TE Connectivity

Product Change Notification: PCN-26-287181

Positive Lock Terminals

General Description of Changes

Current Packaging

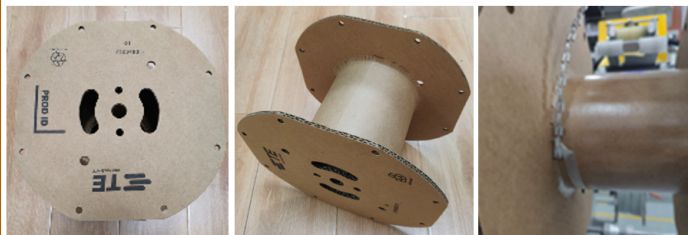
1. Reel without reel core hole
2. Fix with tape.

Future Packaging

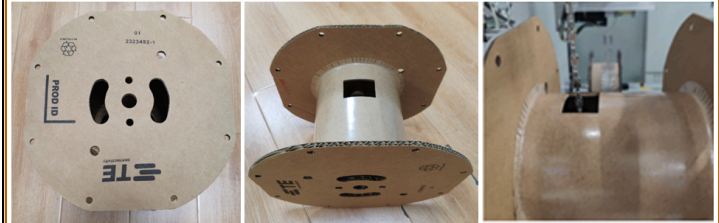
1. Reel have reel core hole
2. Fix with reel core .
